ENGINEERING EVALUATION / COST ANALYSIS FOR ARSENIC IN SOIL

SPRING VALLEY OPERABLE UNITS 4 AND 5 WASHINGTON, D.C.

Re: Engineering Evaluation/Cost Analysis For Arsenic in Soil – Final, Volumes I, II, and III
Spring Valley Operable Units 4 and 5, Washington, DC
National Guard Bureau Contract No. DAHA90-94-D-0010, Task Order DA01
DERP-FUDS HTRW Project Number C03DC091802

Figure 3-3
Grid Sampled Sites

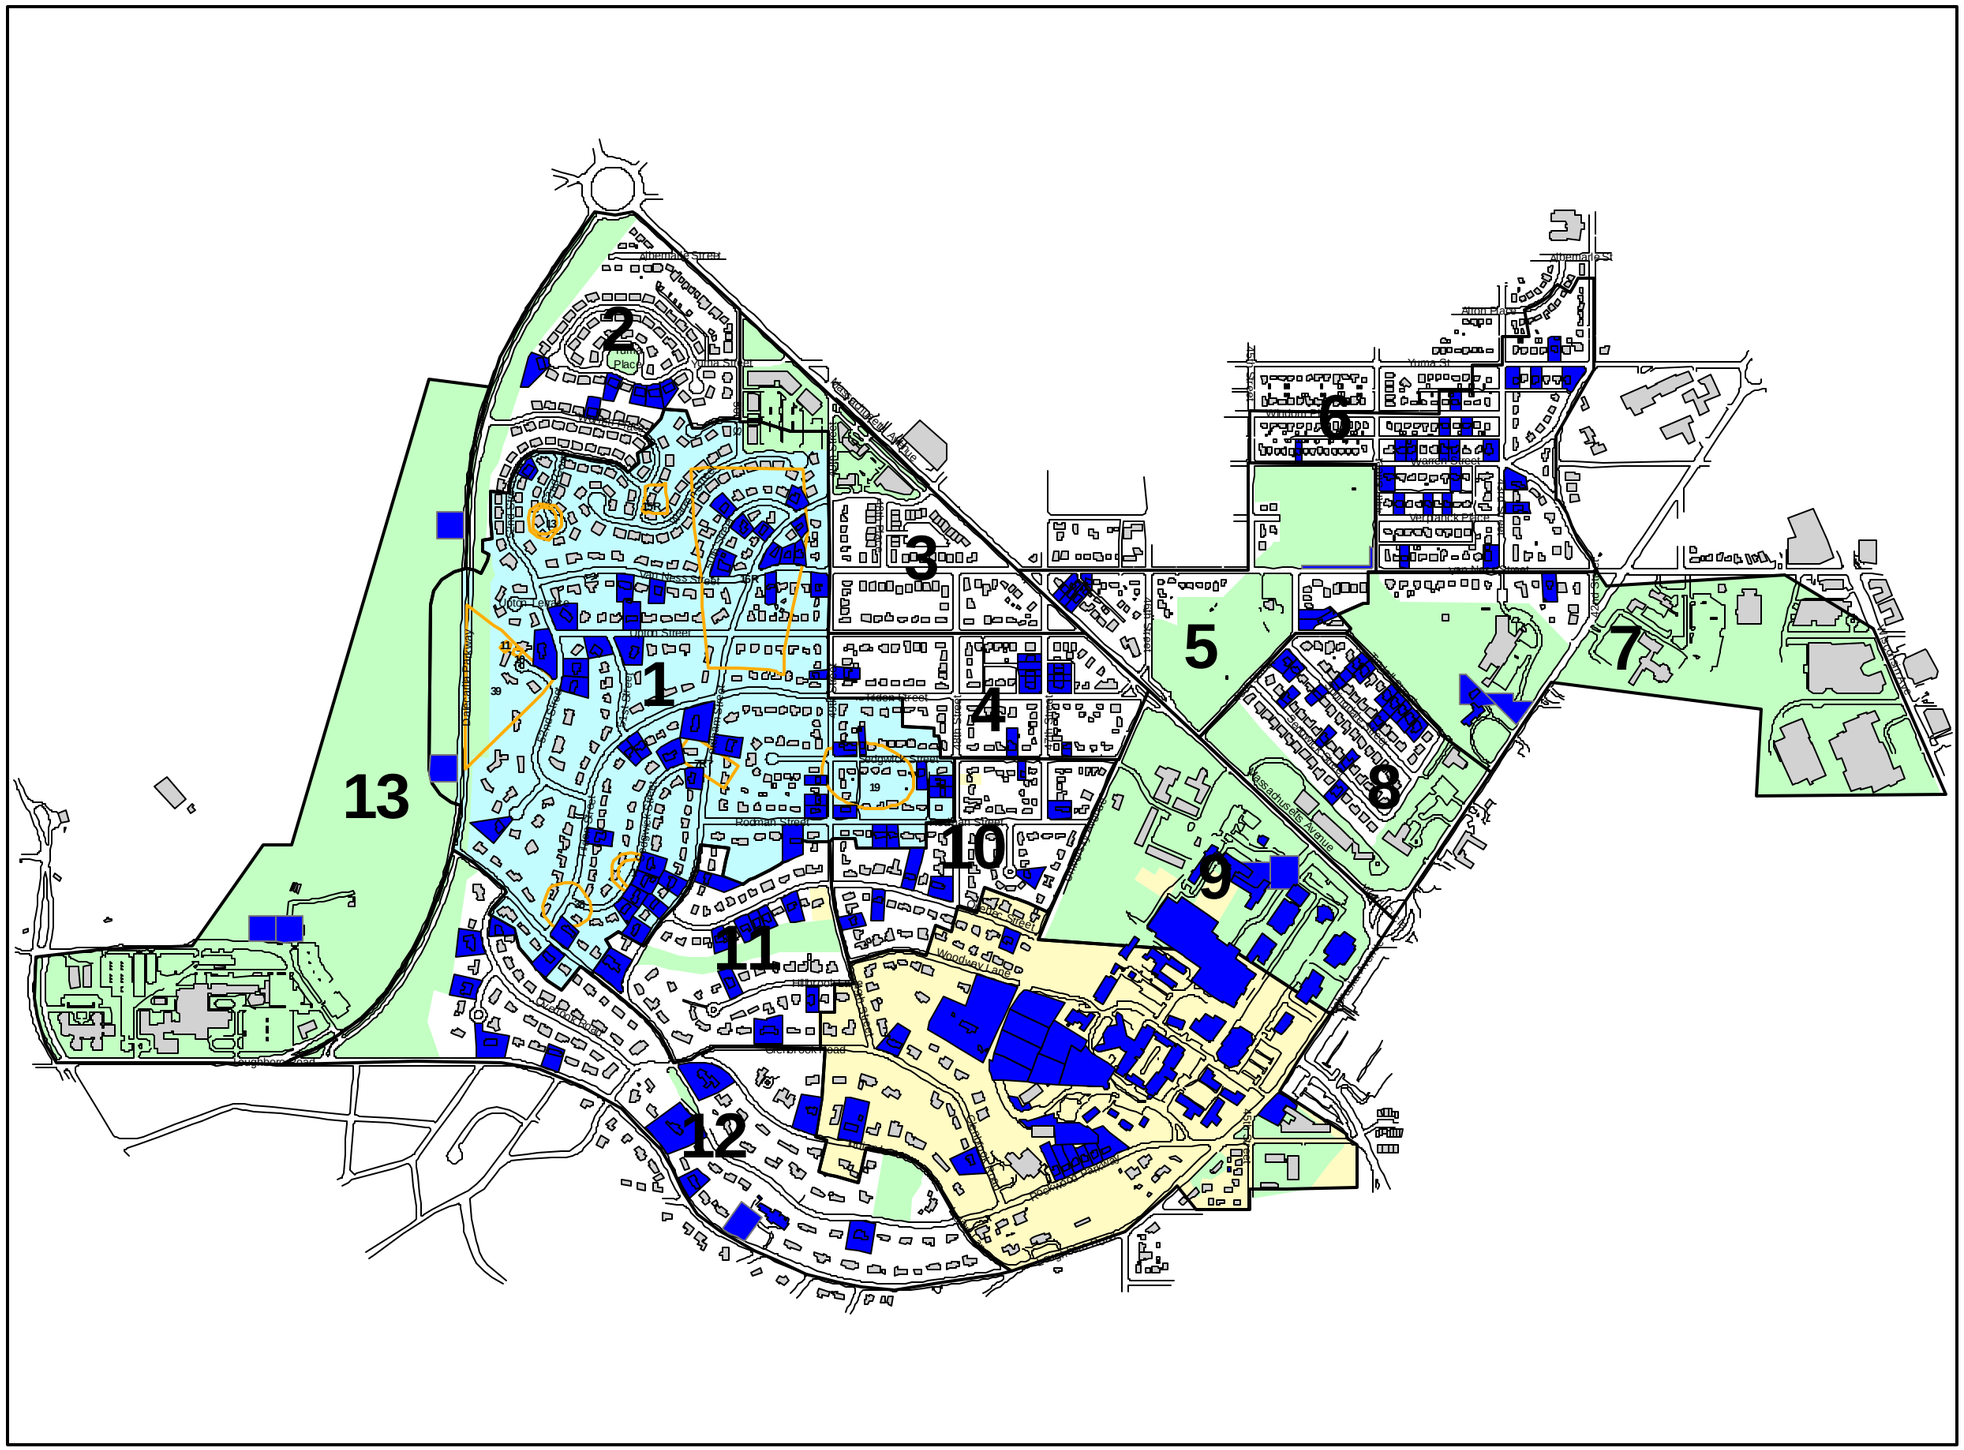
7.	**DCDOH**	7) Figure 3-3. Excellent aid. Suggest adding, " > 12.6 ppm to definition of blue block. **RESPONSE**: Figure 3-3 has been revised to indicate that a site needed to exceed the 12.6 ppm arsenic screen in order to be grid sampled.

Figure 4-1
Grid Sampled Sites
(Showing Relative Arsenic Concentrations)

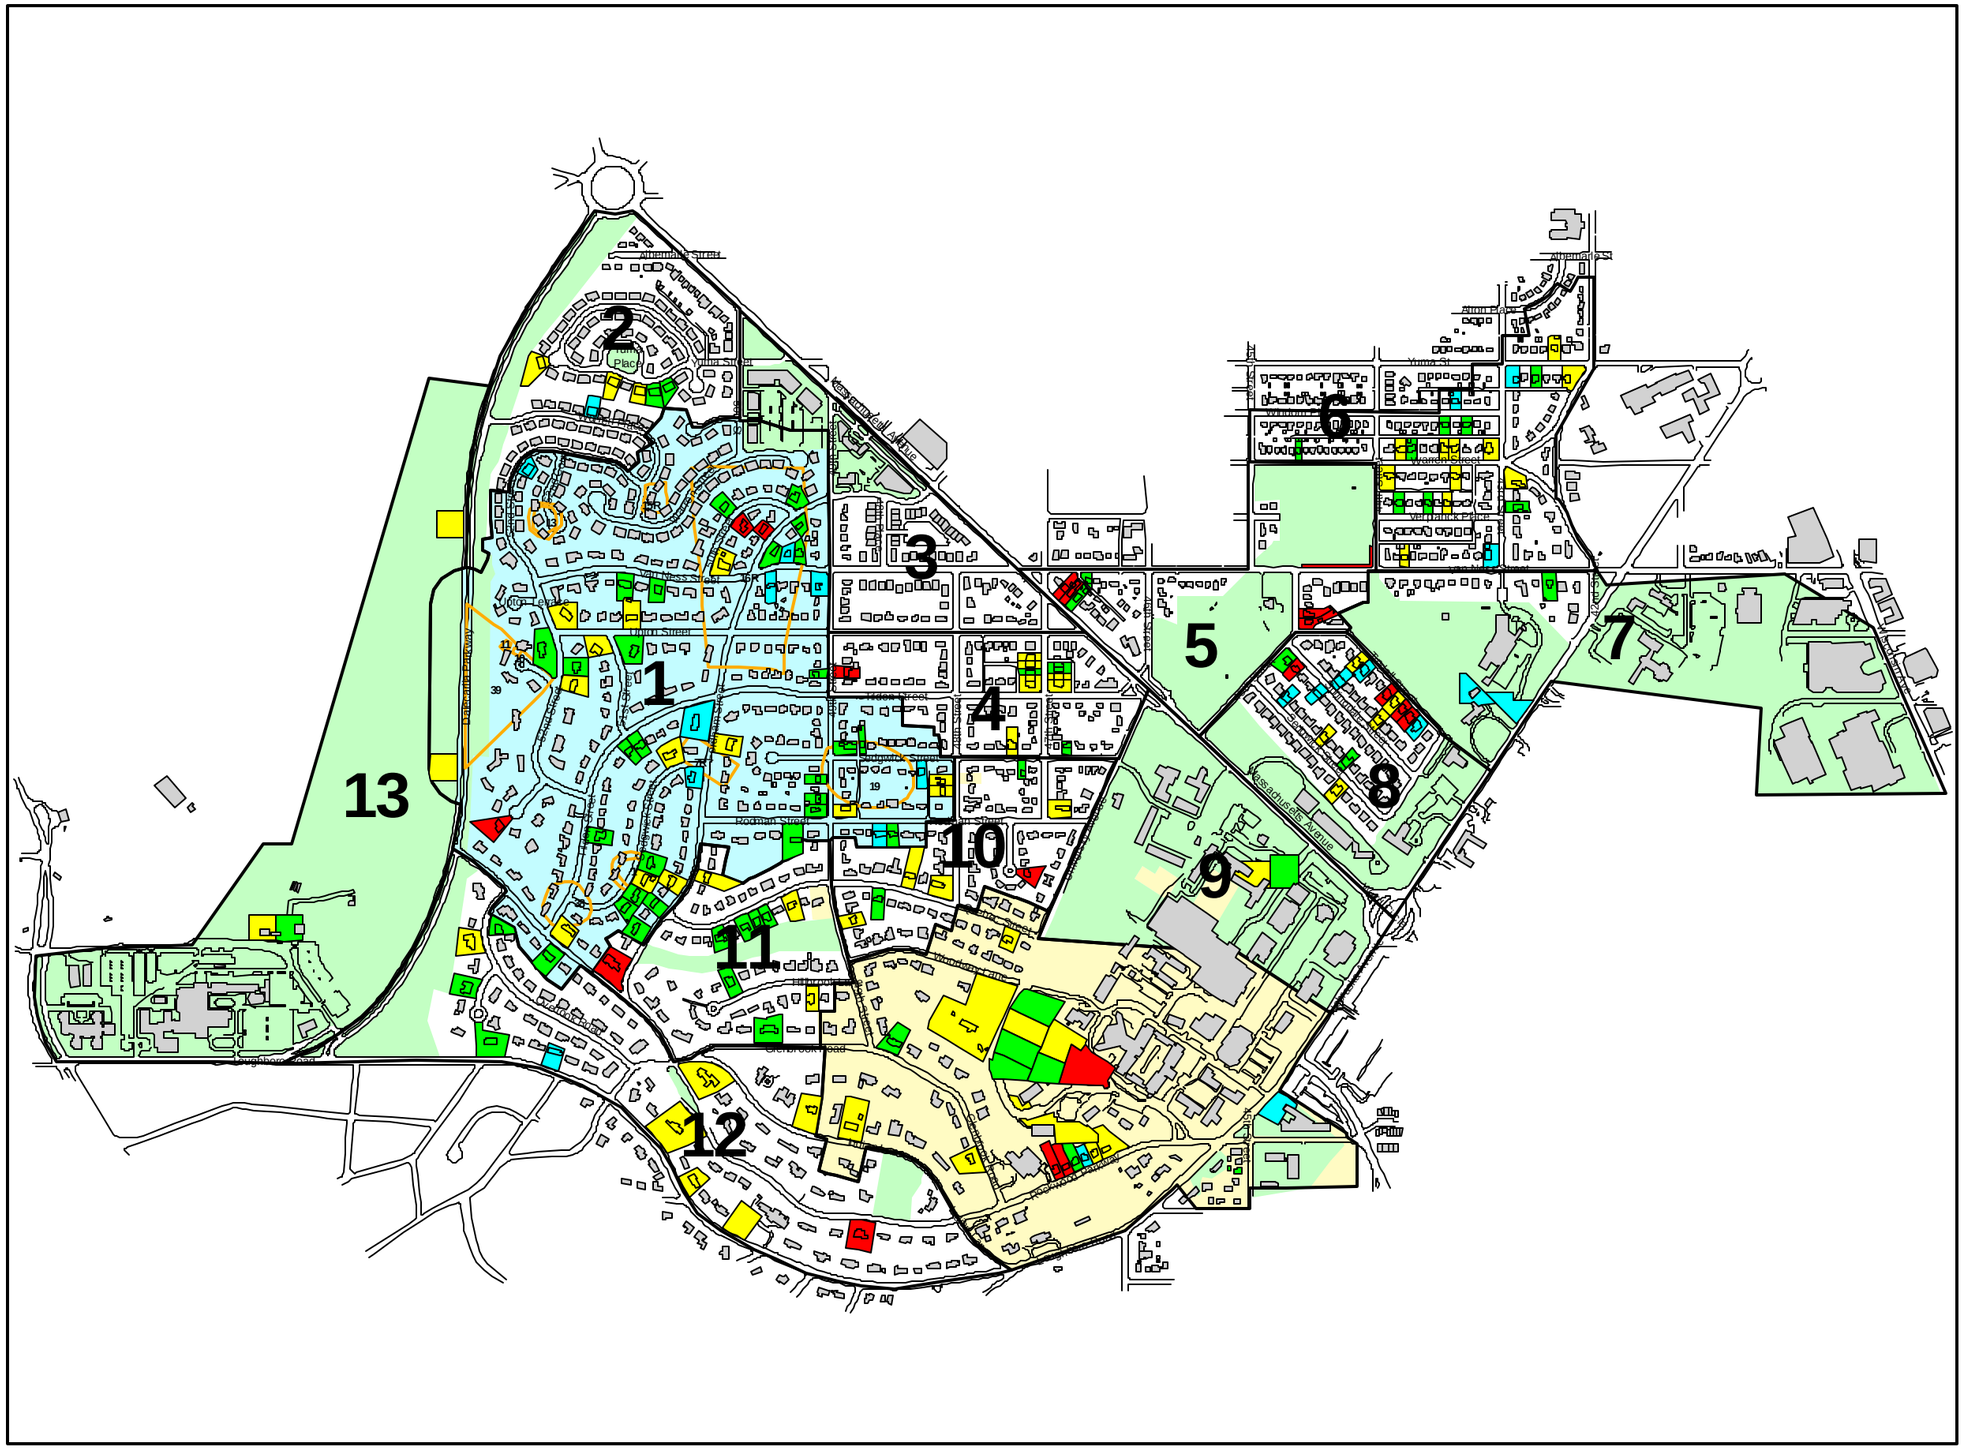
8.	**DCDOH**	8) Figure 4-1. Excellent aid. DOH believes that the definition of blue block is incorrect as that broad definition should cover all of Spring Valley. Suggest 12.6 to 20 ppm. Should include arsenic readings for 4801, 4825 and 4835 Glenbrook Road properties. Should add a fifth color for arsenic levels over 400 ppm. Yellow block on AU campus behind Krieger Hall should be blue (or the fifth color) for arsenic reading for small disposal area (i.e. 3350 ppm) and 2450 at nearby excavation. **RESPONSE**: The color scheme is based on the grid results, not the quadrant/half screen results. Since some of the grid sites contained grids with concentrations lower than 12.6 ppm, the definition of the blue block is correct. No decisions were made based on the concentration of 400 ppm that were not made for the sites exceeding 150 ppm. Therefore, to keep the figure readable and user friendly, a fifth color was not used. This figure is presenting the grid results, a very specific set of data. It does not include every arsenic sample collected, and therefore does not include the SDA or other excavation results. To ensure that the reader realizes that those other areas of high arsenic were not ignored, a statement has been added to acknowledge these other areas and other significant sample results.

Figure 4-2
Specialty Parameter Detections
(Not Including AUES List Sampling)

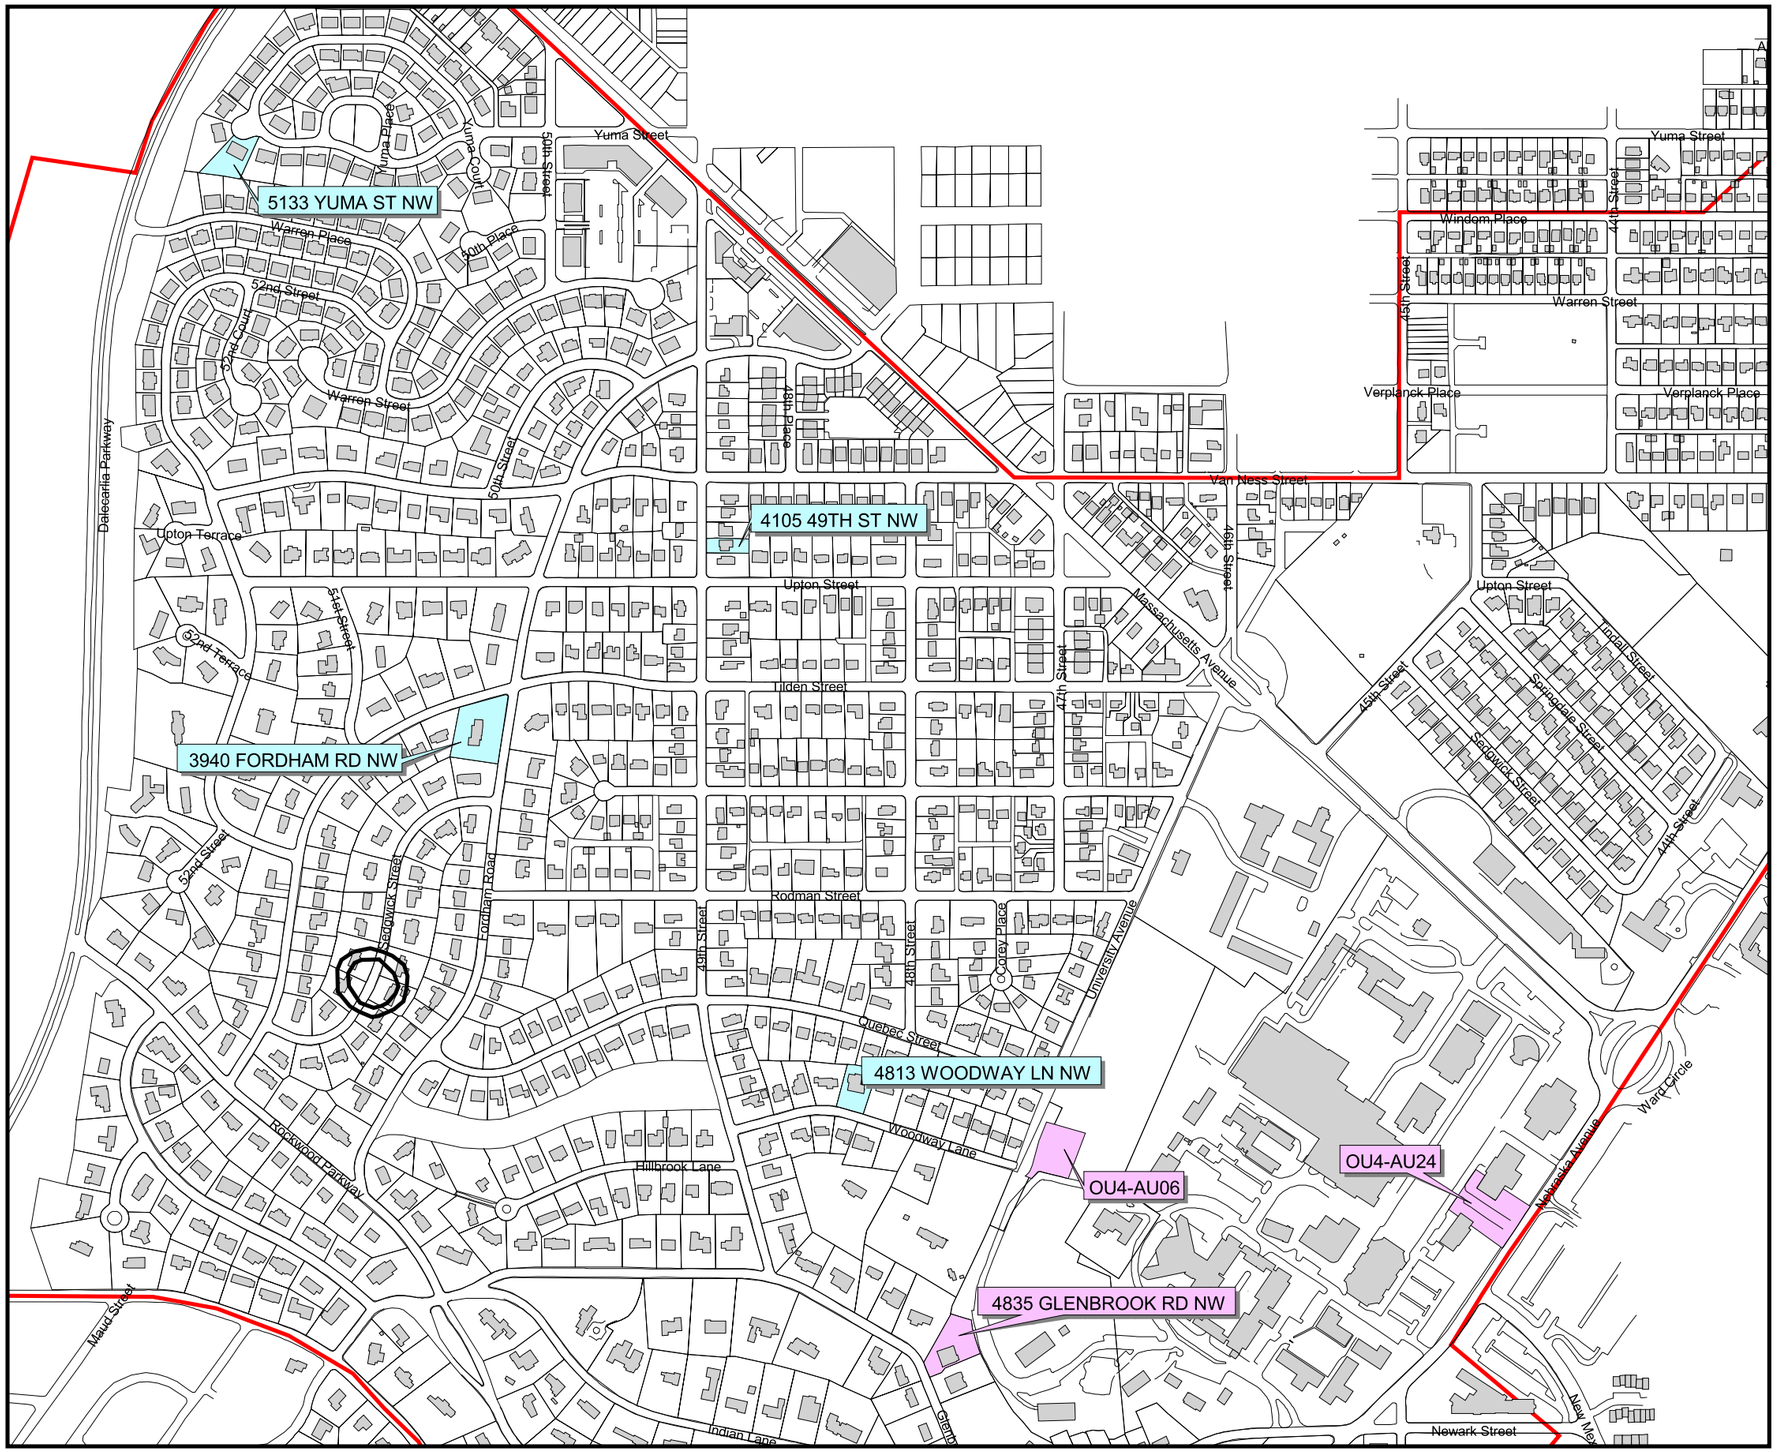
9.	**DCDOH**	9) Figure 4-2. Excellent aid. Should cover all of current FUDS boundary. Should cover all sample results for the two constituents (possibly using a different color for other sampling efforts). (i.e. thiodiglycol reading on 4625 Rockwood Parkway and 52nd court trench from CBDA sampling. Cyanide reading at Sedgwick trench). Also recheck Corey Place data. **RESPONSE**: Generally, data presented in figures in this EE/CA reflect activities performed for the EE/CA. Data from other past sampling events are not shown, to ensure the document does not deviate from its express purpose and objectives. Specifically, Figure 4.2 is described in Section 4.4 as one that presents the EE/CA sampling results <u>other than the AUES list</u>. The 4625 Rockwood thiodiglycol detection was from the AUES List sampling. Those results will be assessed in detail in another document. No data regarding any non-arsenic detection at a Corey Place residence could be found.
